**FUTURE MELBOURNE (PLANNING) COMMITTEE
SUPPLEMENTARY REPORT**

CITY NORTH STRUCTURE PLAN

7 February 2012

**FINAL DRAFT CITY NORTH STRUCTURE PLAN – REPORT ON THE
COMMUNITY CONSULTATION 6 Dec 2011 – 6 Jan 2012**

Figure 3.8 Proposed built form controls within City North

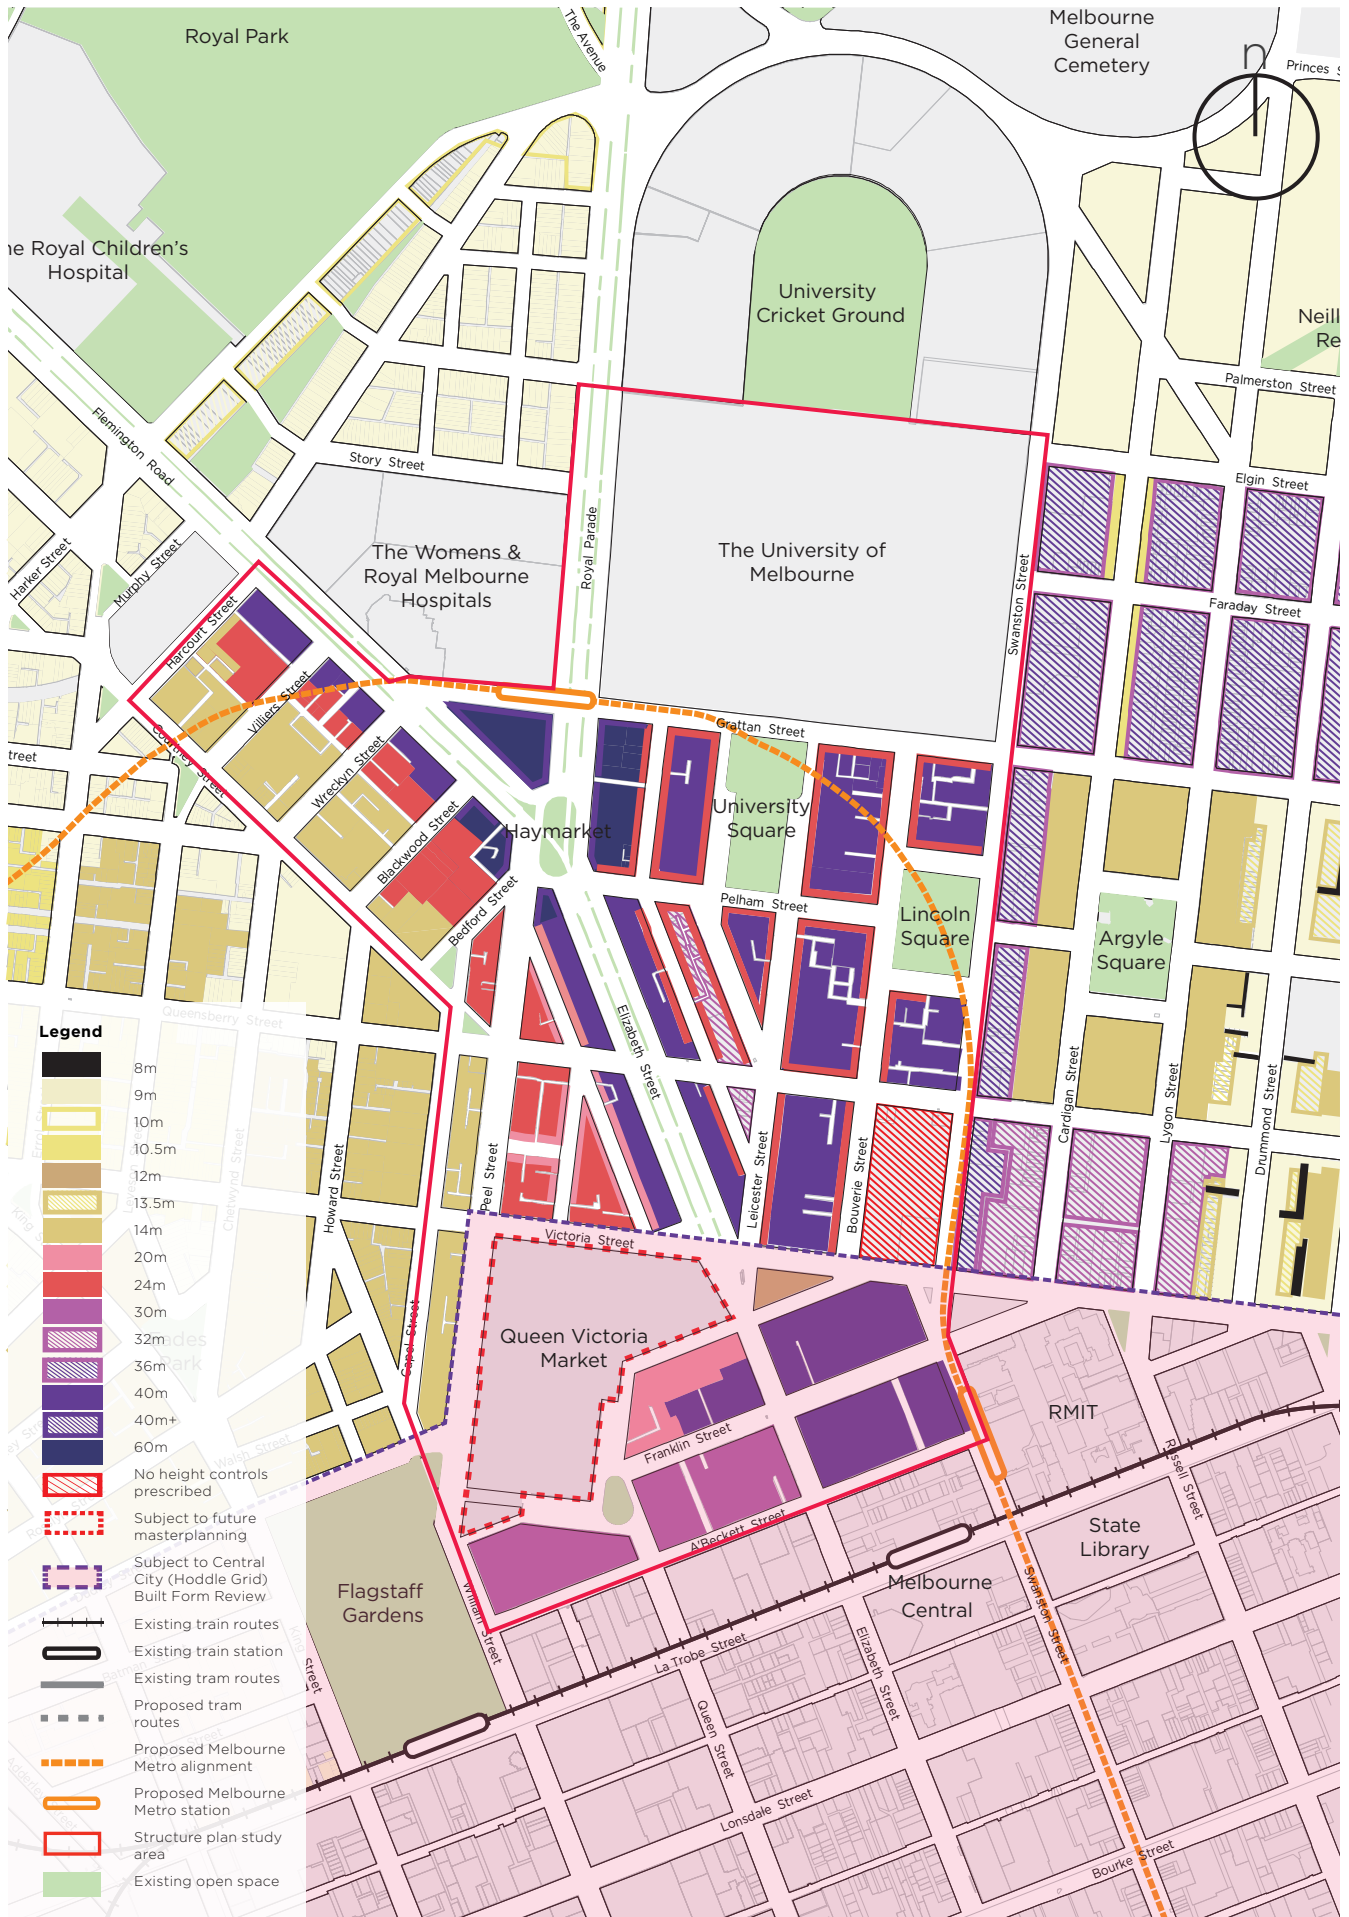
d. It is further unnerving to look at Figure3.8. The colour code for the east side of Courtney St indicates a height range of 14-16m. It needs to be clear that it is a 14m limit.	d. Update key in Figure 3.8 and text to show the 14 metre height control along Courtney Street retained and include a new colour to indicate the 16 metre height controls.	d. To clearly denote the retention of the 14 metre height control along Courtney Street and the areas of 16 metre height controls.

c. Request 14-16m max along Courtney St becomes 14m max [as per existing DDO32].	c. Update key in Figure 3.8 and text to show the 14 metre height control along Courtney Street retained and include a new colour to indicate the 16 metre height controls.	c. To clearly denote the retention of the 14 metre height control along Courtney Street and the areas of existing 16 metre height controls.

l. DDO32 should remain as a mandatory control, and should remain at 14m, not 14-16m.	l. Update key in Figure 3.8 and text to show the 14 metre height control along Courtney Street retained and include a new colour to indicate the 16 metre height controls.	l. To clearly denote the retention of the 14 metre height control along Courtney Street and the areas of existing 16 metre height controls.

Major Changes		
3.1	Refine transition of heights from 14m in Courtney Street to 40m in Flemington Road. (Replace figure 3.8 with figure A in attachment 2).	To ensure appropriate transition of development scale and heights from stable residential areas to the urban renewal areas to protect existing residential amenity and character.
3.2	Incorporate clarity on extent of mandatory and discretionary height controls.	To provide certainty on preferred future development outcomes

Minor Changes		
Item	Proposed Change	Reason for Change
3.3	Update key in Figure 3.8 and text to show the 14 metre height control along Courtney Street retained and include a new colour to indicate the 16 metre height controls.	To clearly denote the retention of the 14 metre height control along Courtney Street and the areas of existing 16 metre height controls.
3.4	Include before and after plan for proposed height controls.
